DVP22-0007 1786 Crosby Road

Development Variance Permit Application

➤ To review a Staff recommendation to <u>NOT</u> issue a Development Variance Permit to vary the maximum site coverage and the minimum rear yard for a deck addition to a single detached house.

Project details

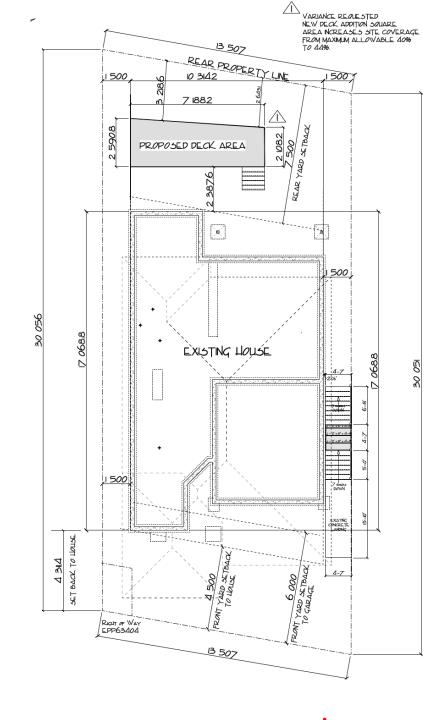
▶ Deck addition was constructed without a Building Permit.

- ▶ Deck is located 2.64 m from the rear property line. A 6.0 m rear yard setback is required.
- ► Addition of deck increases site coverage to 44%. Maximum site coverage is 40%.
